M-13 Revision 91

Frank Hartman
Supervisor, System Operations
Markets & Reliability Committee
November 15, 2023

M-13 Version 91 Revisions

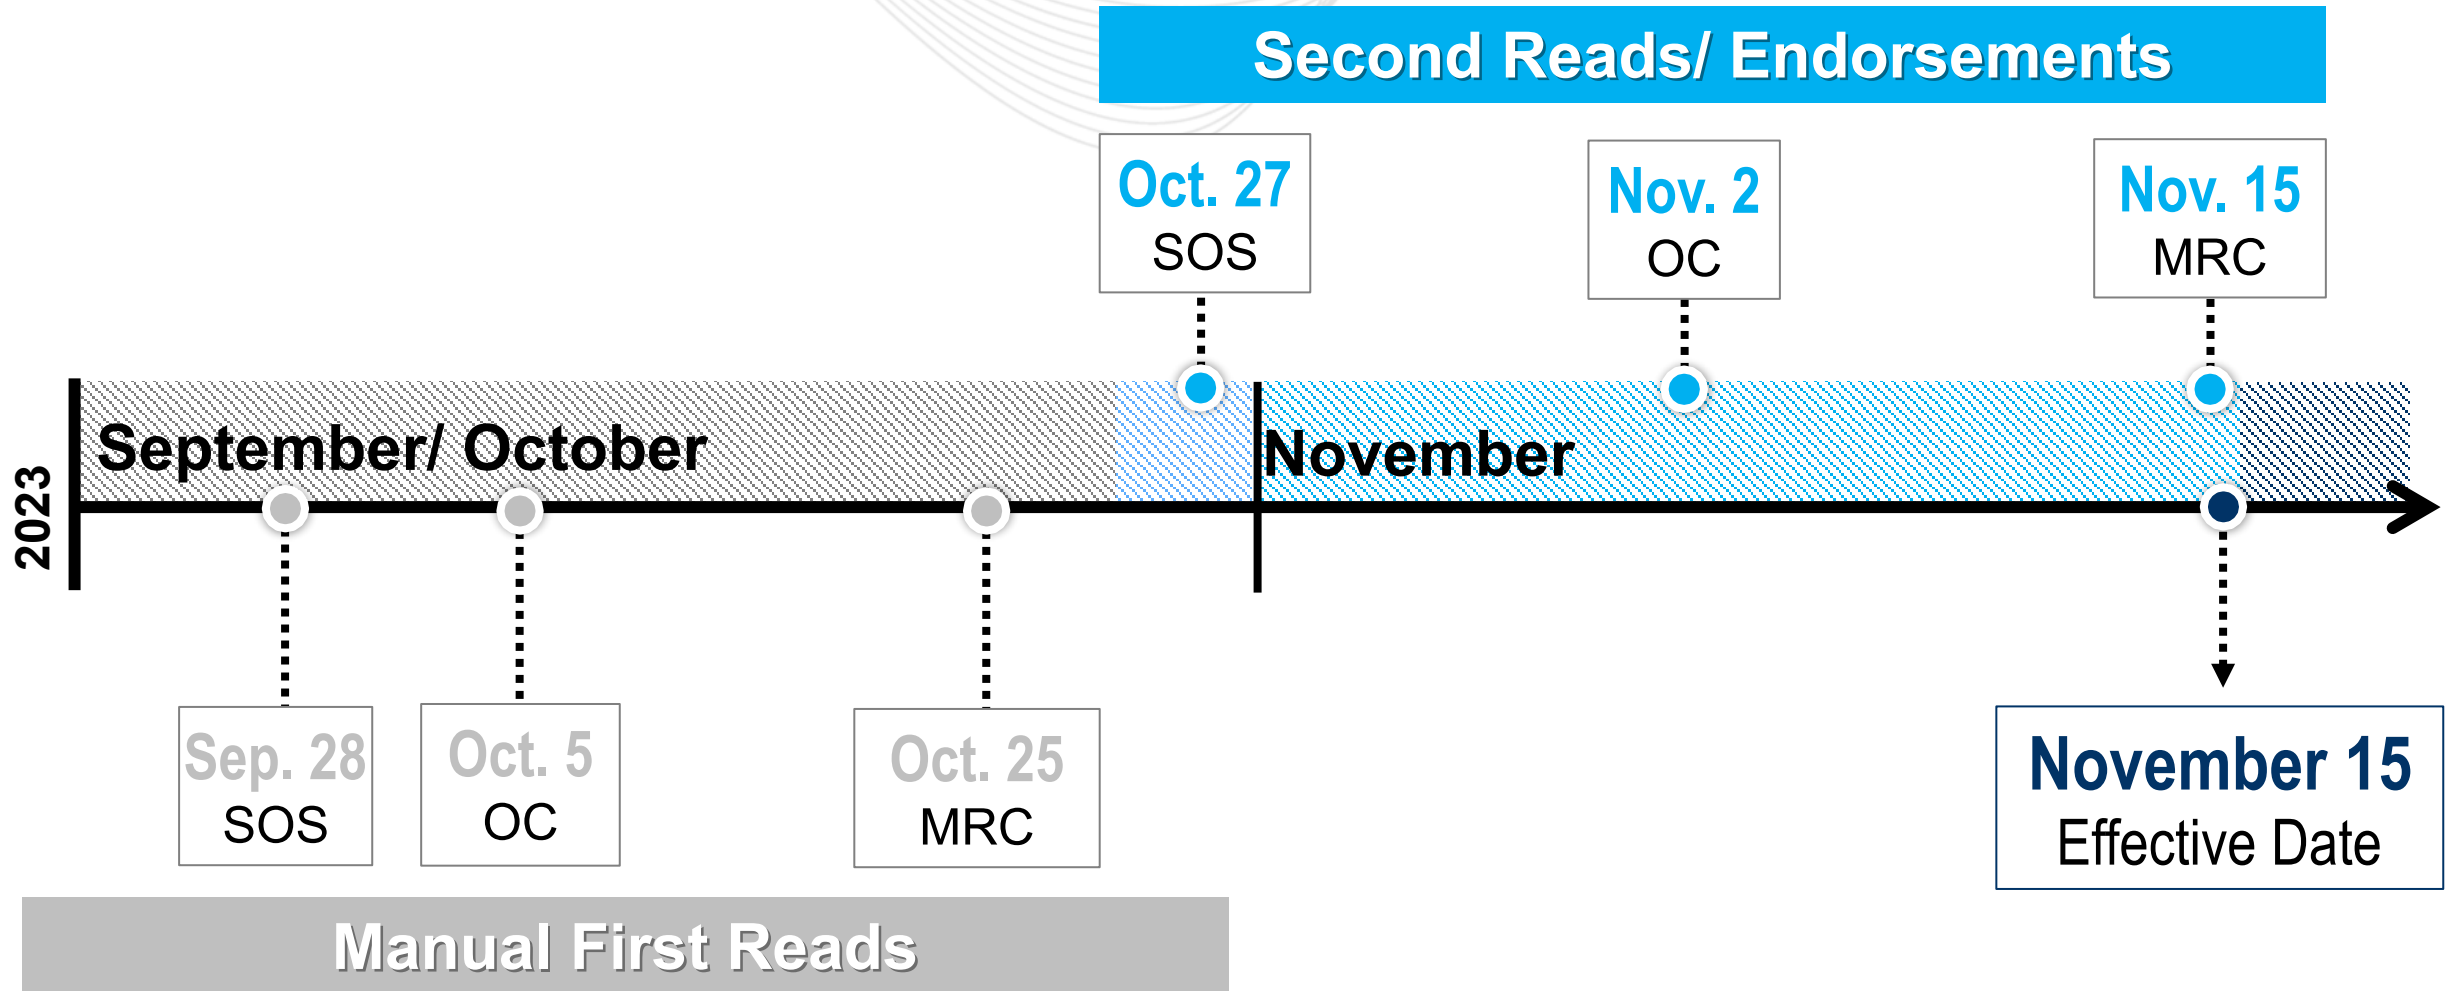
- ***Problem Statement***

- After a public notification statement was declared in December of 2022, the procedure was reviewed after the fact for accuracy
 - It was determined there was a need to better highlight the urgency of a conservation request, clarify that request is being made of all electricity users, not just residential customers, and provide more specific energy conservation tips
- PJM has a DOE-417 requirement for reporting when declaring such an event
 - M-13 was reviewed to better integrate this step with other emergency procedures for better clarity.

- ***Issue Content***

- The goal is to provide additional clarity to the existing public notification and associated DOE-417 procedure

- ***Expected Deliverables***

- M-13 edits to Section 2.3.2 & 5.2; Section 4.3, 4.4, 4.4.3 to include PJM's DOE-417 event reporting and Attachment A: Public Notification Statements
